IMPORTANT !

This replenish pump has no diode built in as the previous pumps.

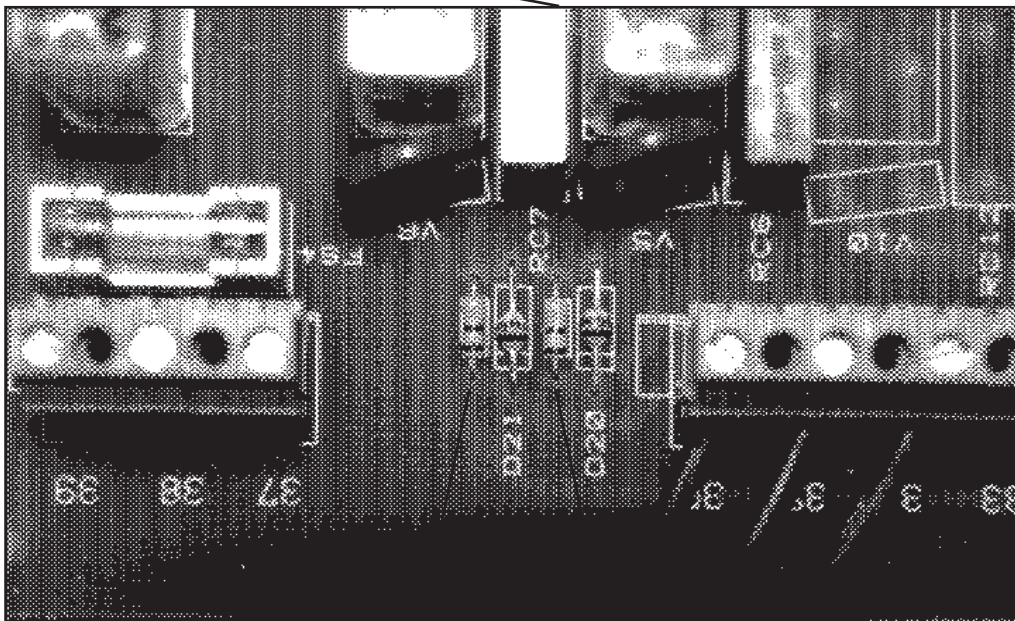
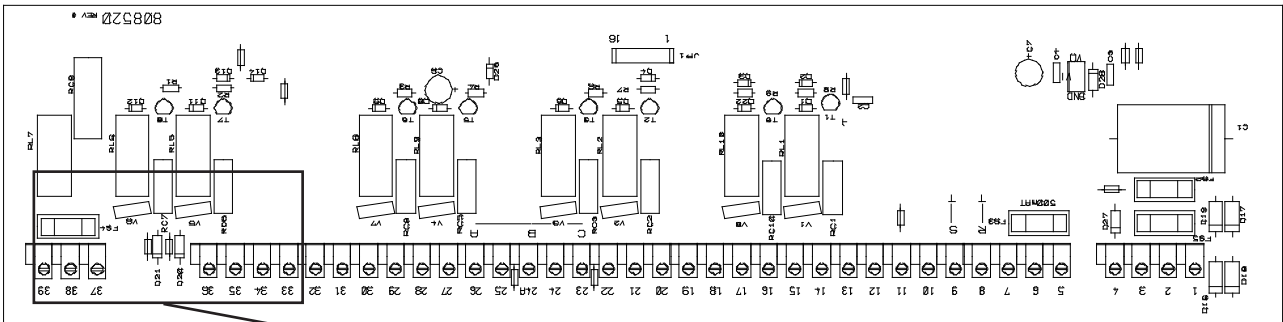
Therefore it is necessary to cut the respective short circuit-resistor on the Relay PCB (**Not necessary on processor with microprocessor control**).

If the pump is going to replace the developer pump, cut the short circuit-resistor on the left hand side of diode D20 on the Relay PCB.

If the pump is going to replace the fixer pump, cut the short circuit-resistor on the left hand side of diode D21 on the Relay PCB.

The ground wire must be connected to the ground connection on the pump-chassis.
